JOB TITLE:
 Russell Hotel
 Russell Sq, London

DRAWING TITLE:
 Elevation of Entrance Doors

JOB TITLE:
 Russell Hotel
 Russell Square, London

Door & Frames
GD11.01 & DG23.02

DRAWING NO: WG/1097-RUS-DO1 ISSUE: C

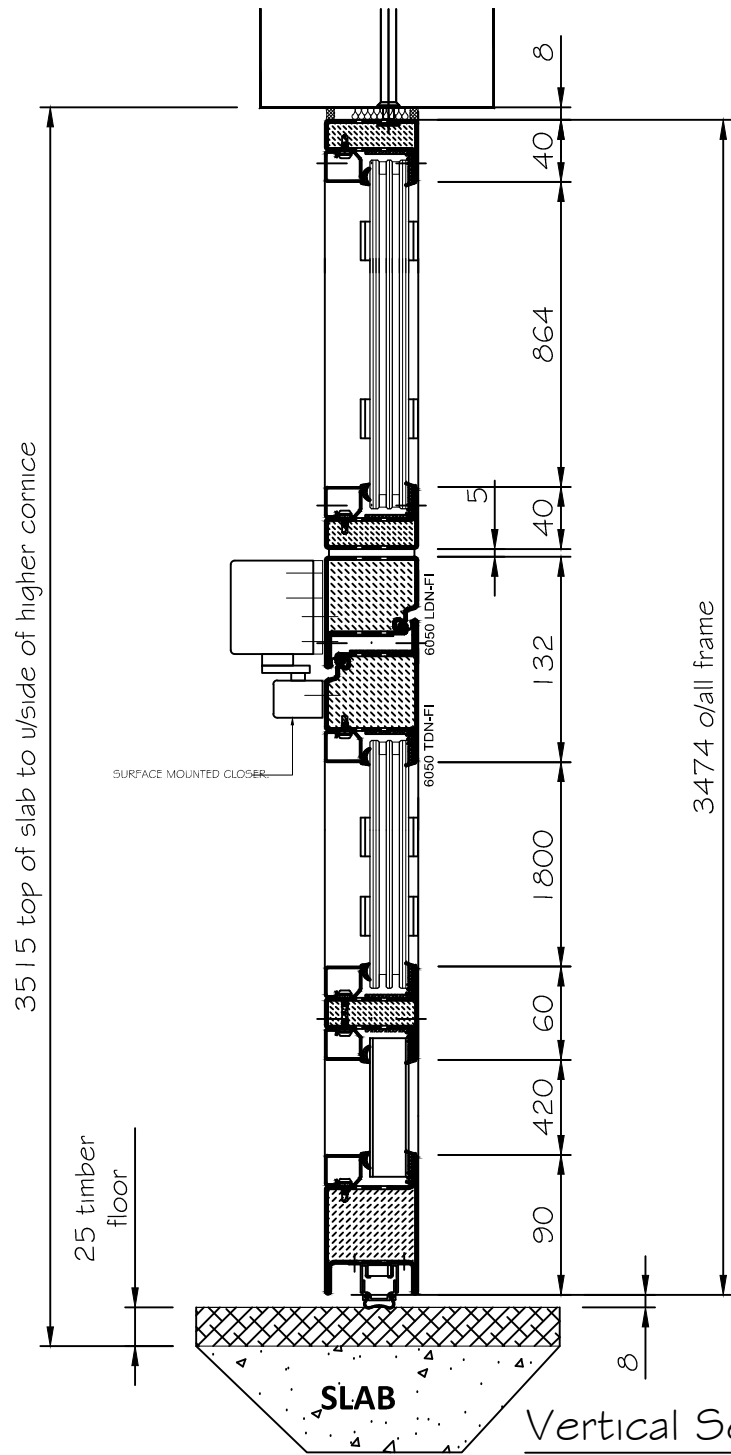
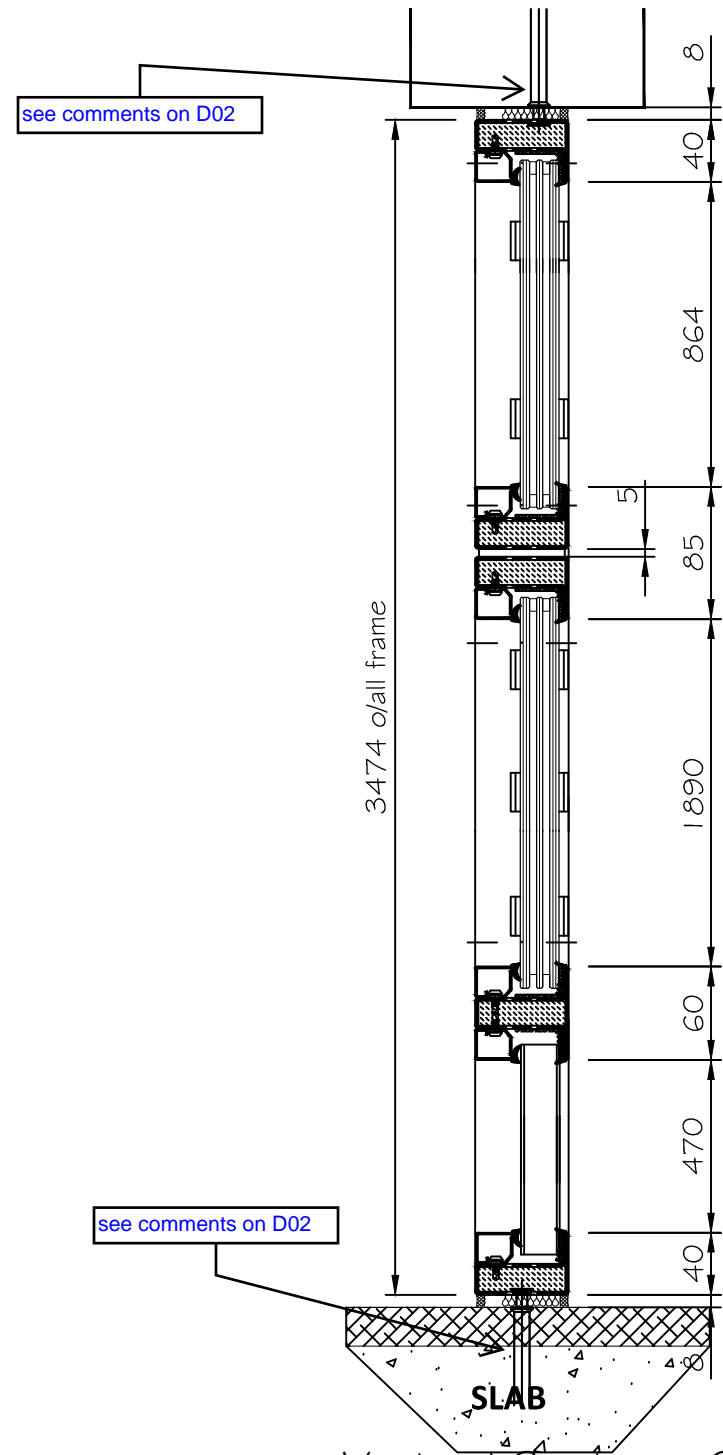
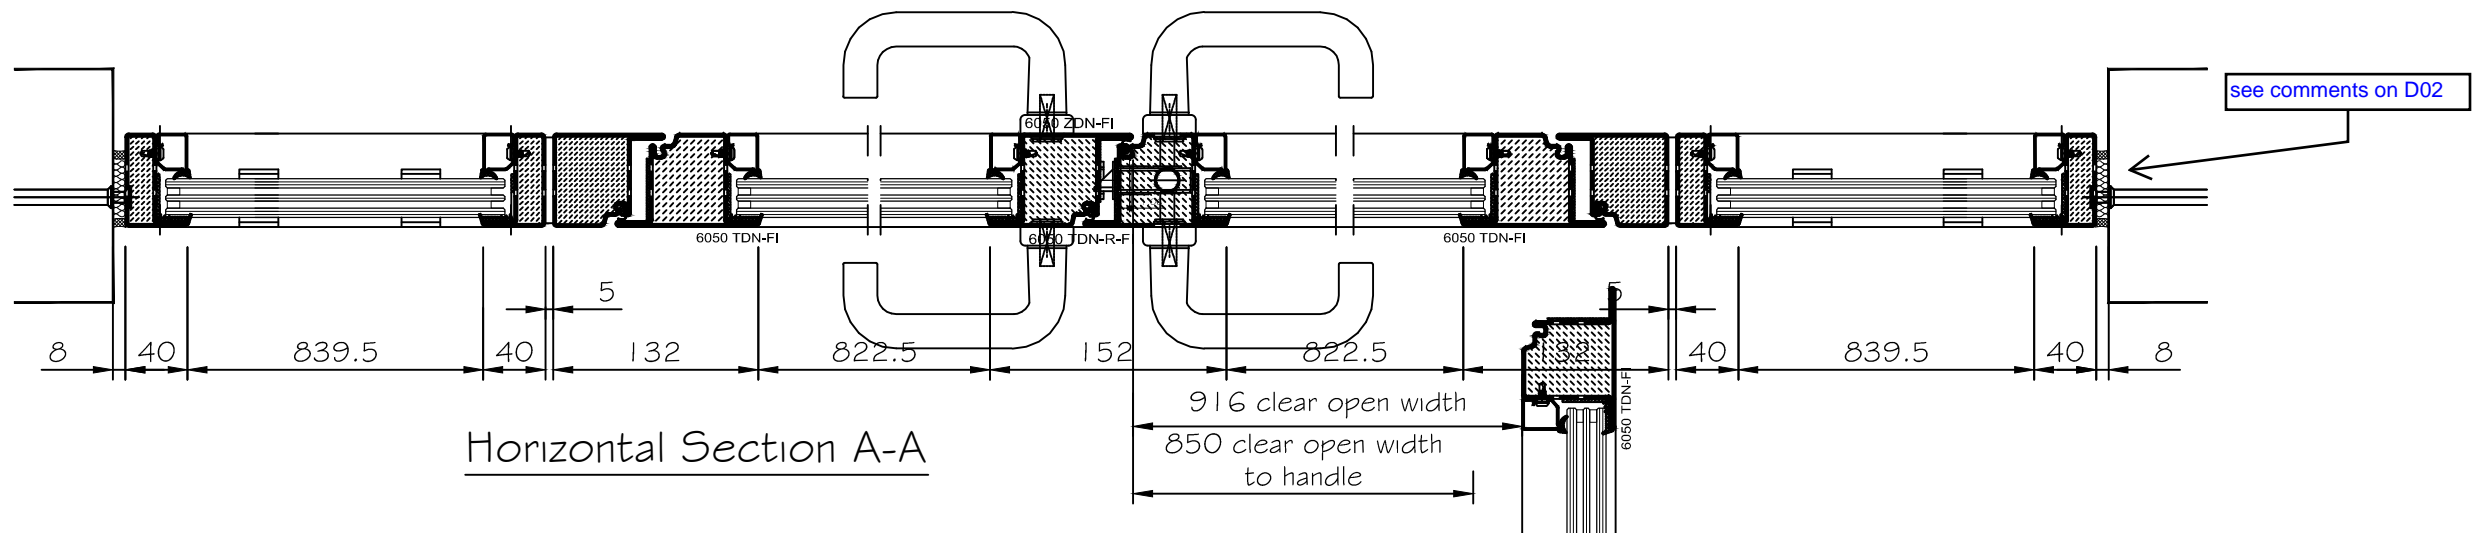
FDKS signage required to both doors both sides - agree location on door with RSS & Epr.

Title: **The Russell Hotel DG10.02**

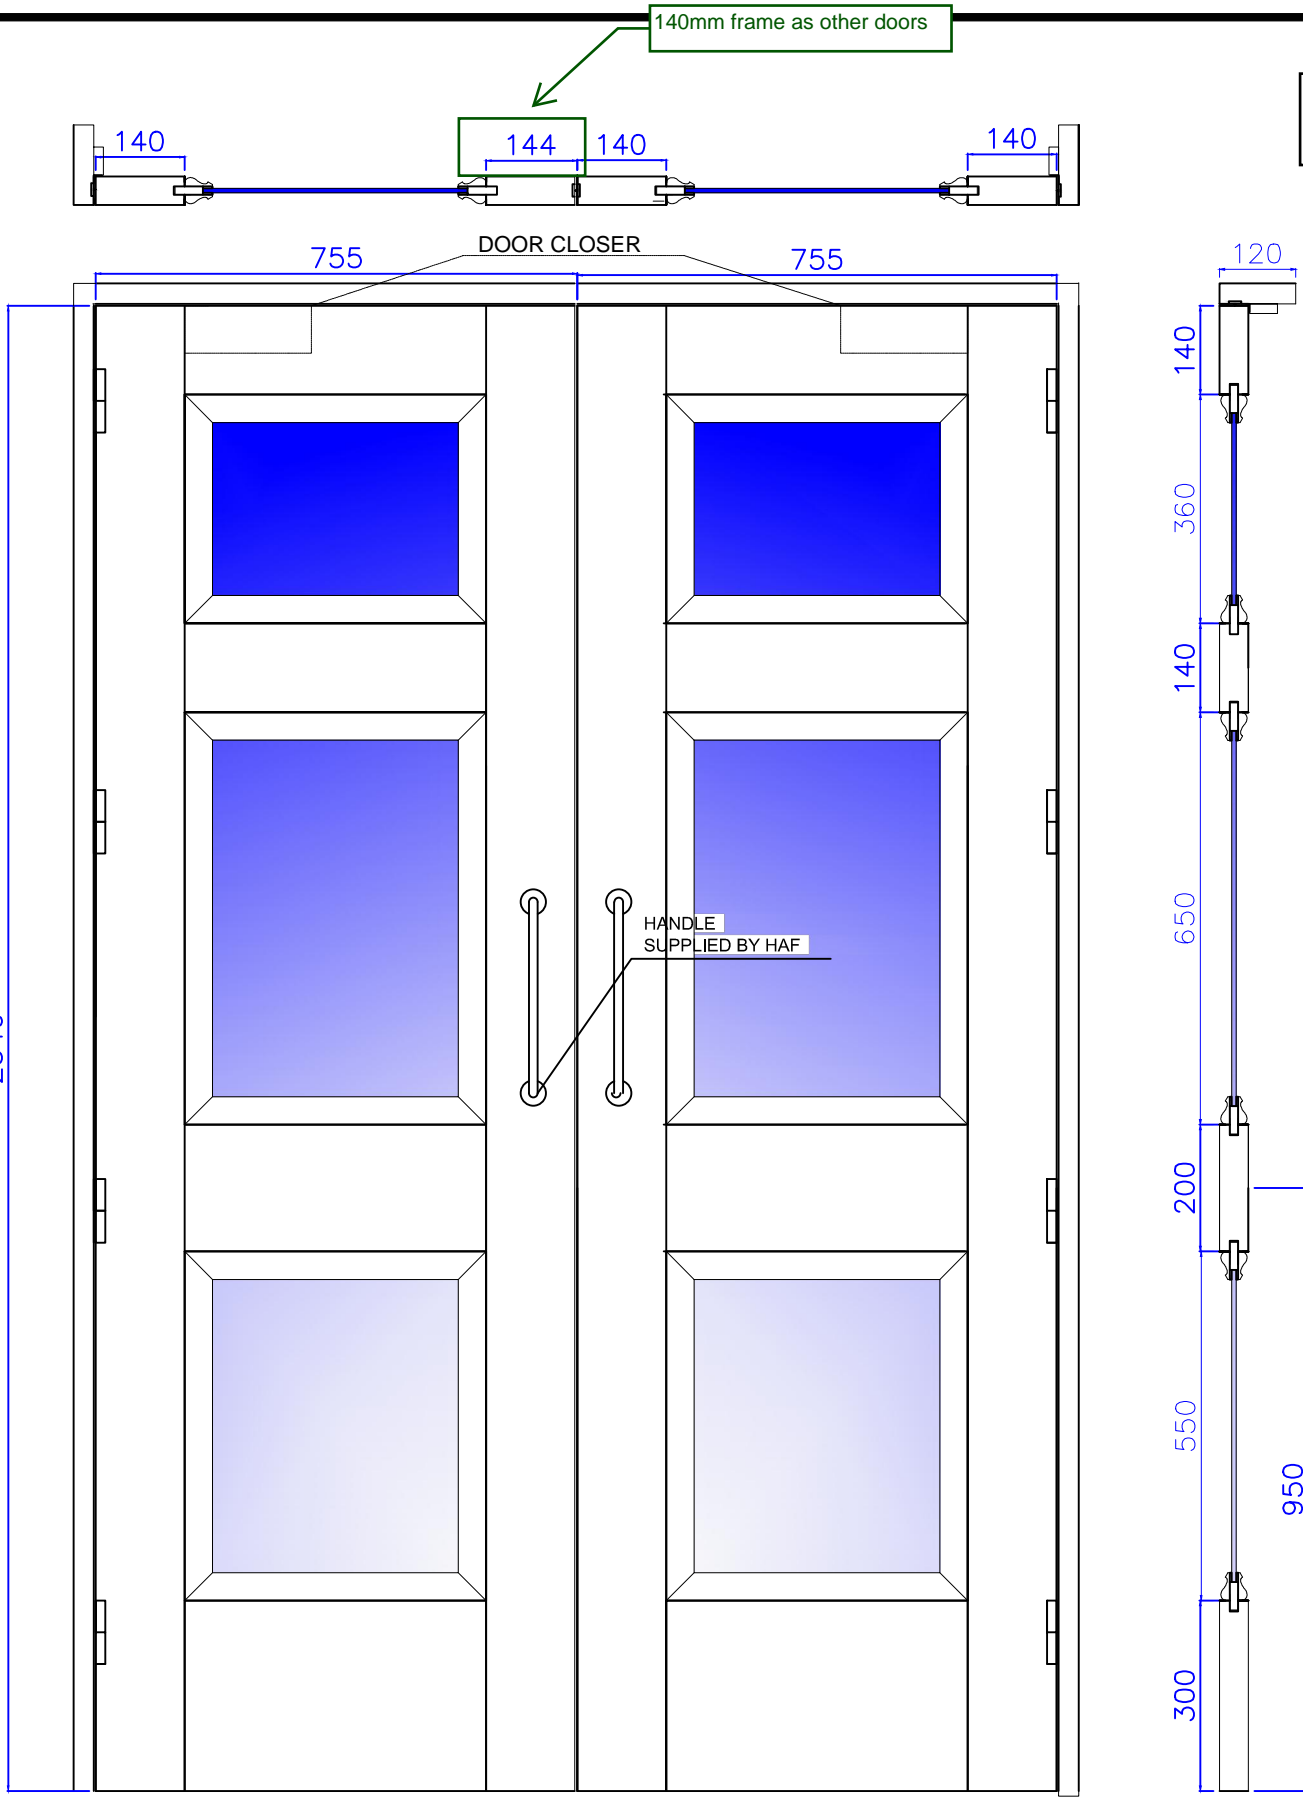
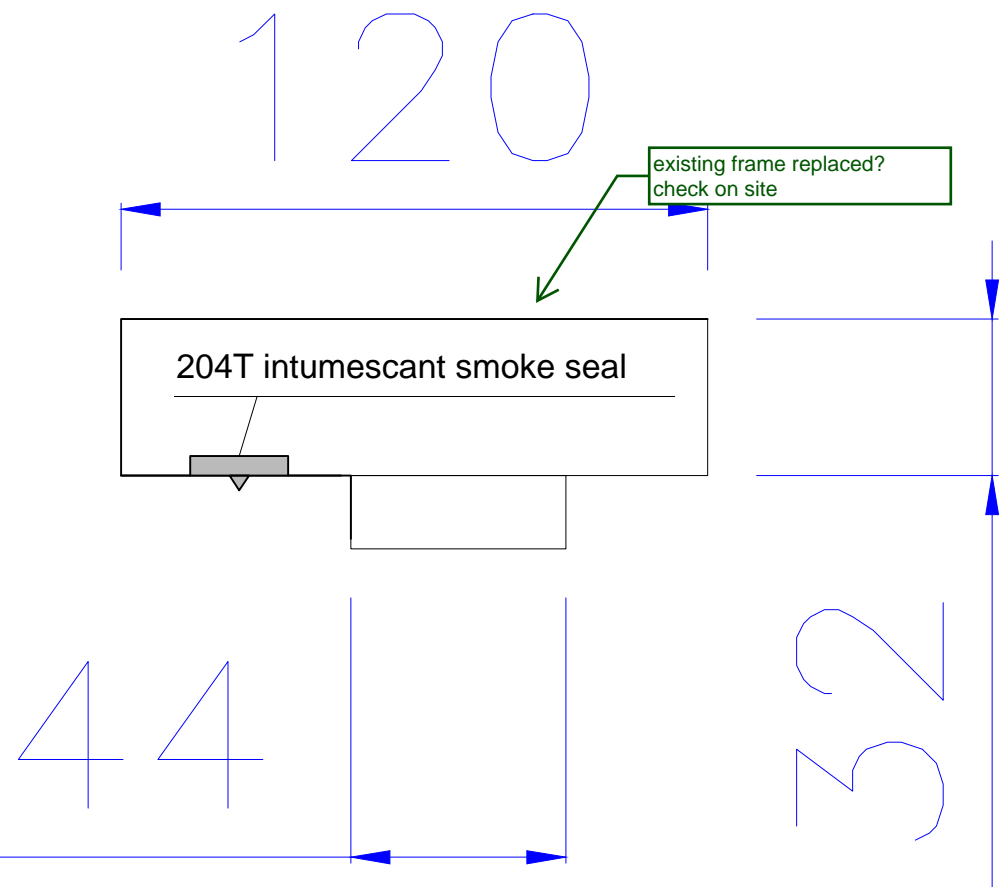
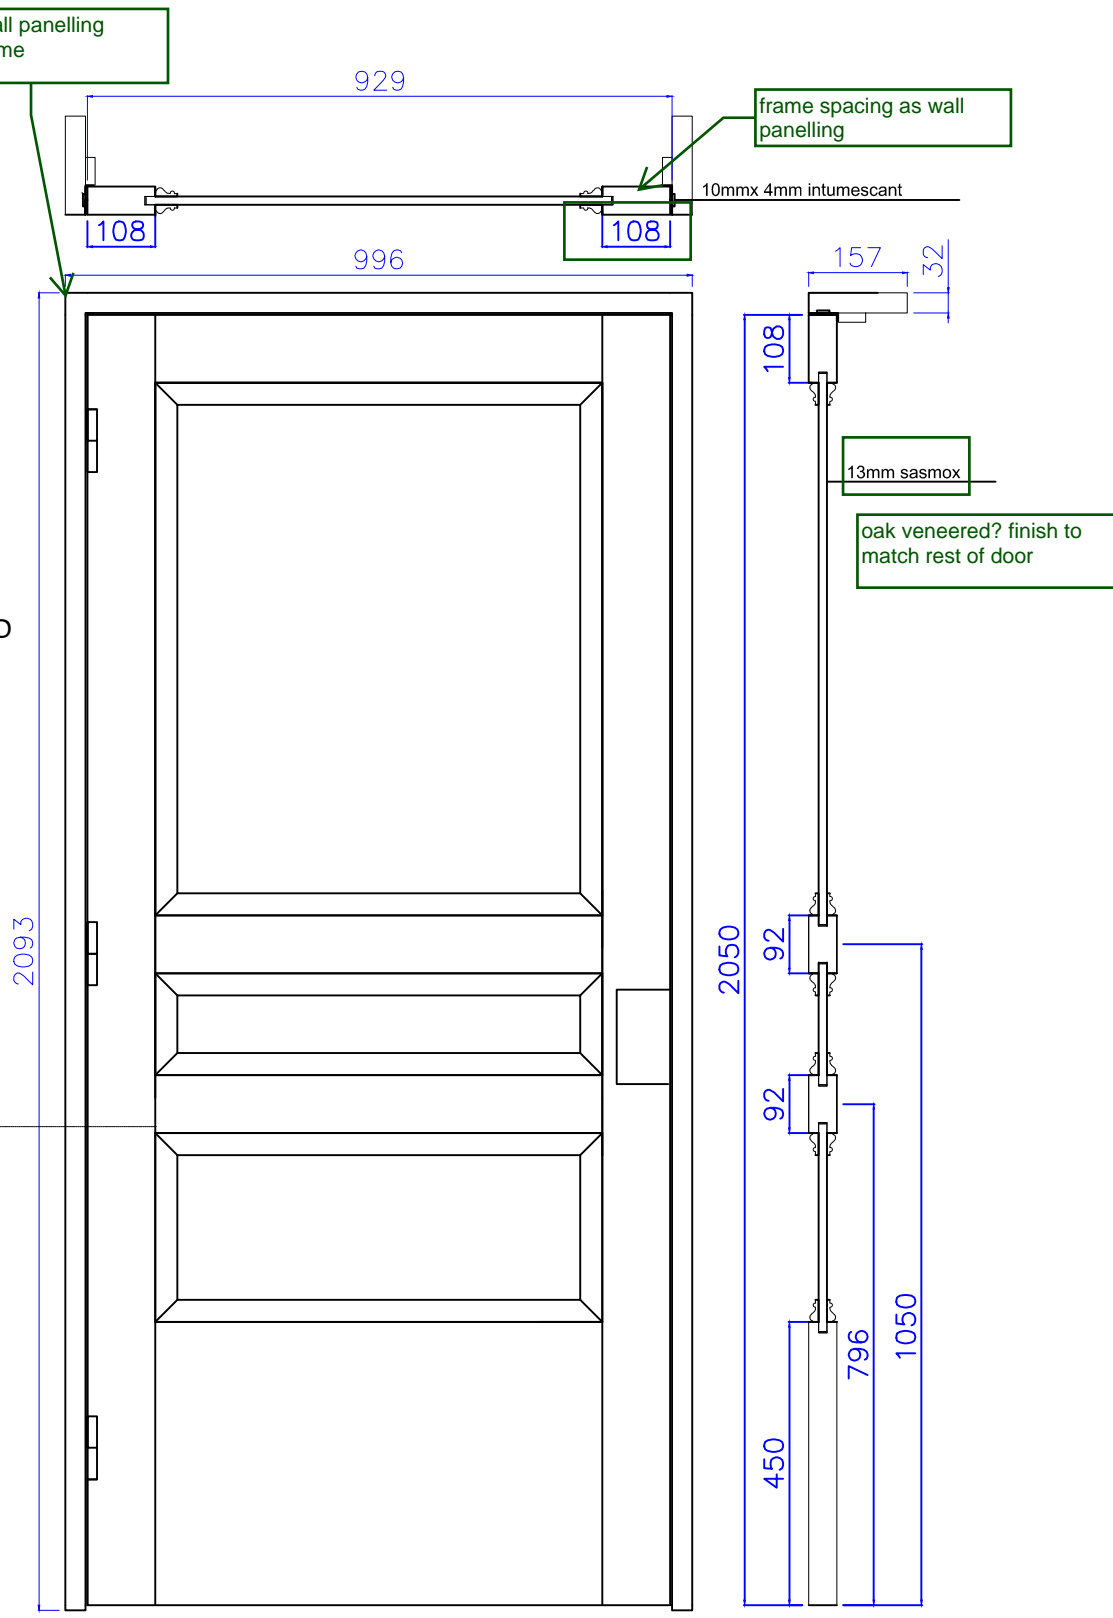
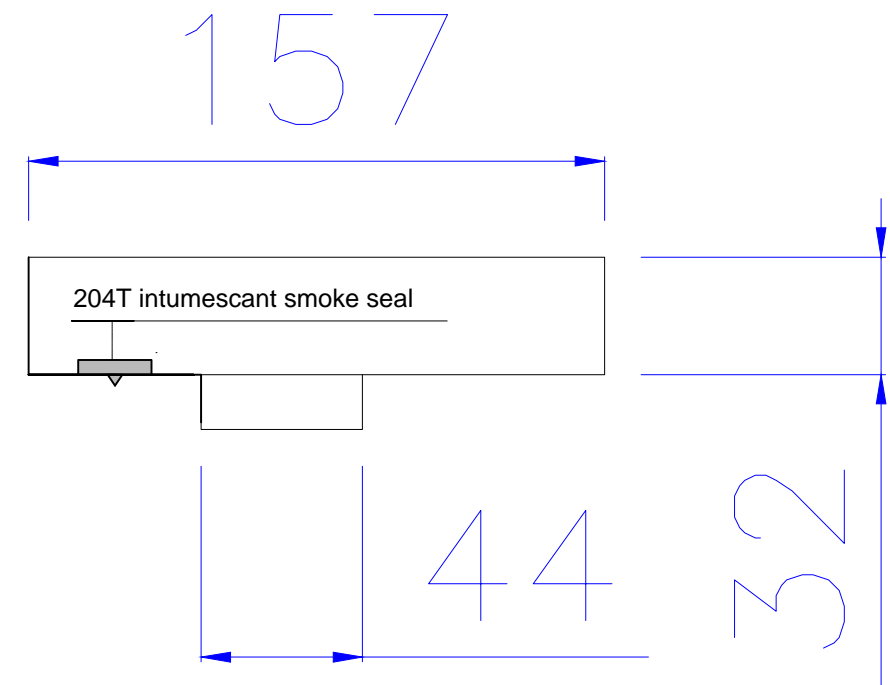
G10 side to be finished to match other Edmonds doors

Epr comments:
 Mouldings and frame widths to match other GF doors - refer to Edmonds door drawings.
 Architraves by others - finish will need to match.
 Fire seals also required at base of door?
 Refer latest HAF schedule to ensure any recessed ironmongery is allowed for e.g. recessed door closers, lock barrels, electronic locking etc
 Doors within existing openings to be site measured.
 Test certificates required at completion for new fire door sets.
 Refer to previous finishes comments from RSS 31.03.17

and alignment with adjacent existing wall panelling

Title: THE RUSSELL HOTEL DG13.01

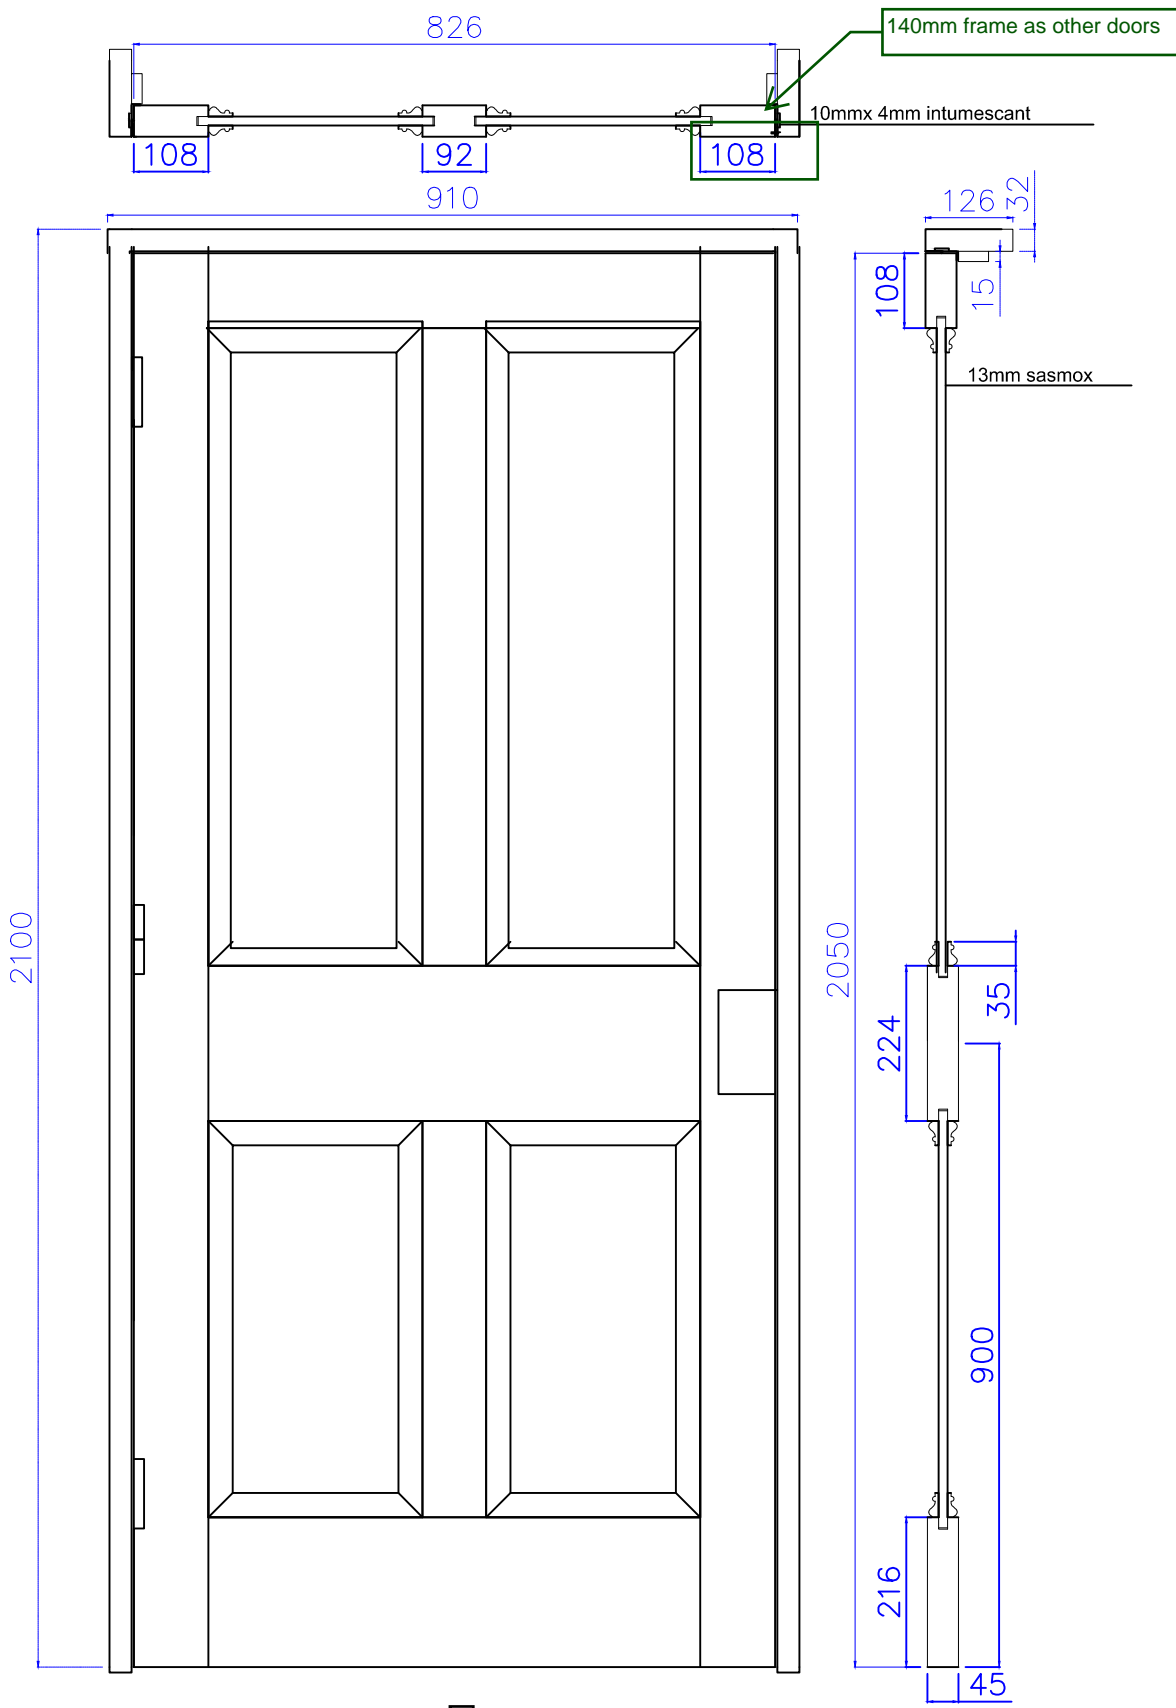
Epr comments:

Mouldings and frame widths to match other GF doors - refer to Edmonds door drawings.

Architraves by others - finish will need to match.

Fire seals also required at base of door?

Refer latest HAF schedule to ensure any recessed ironmongery is allowed for e.g. recessed door closers, lock barrels, electronic locking etc

Doors within existing openings to be site measured.

Test certificates required at completion for new fire door sets.

Refer to previous finishes comments from RSS 31.03.17
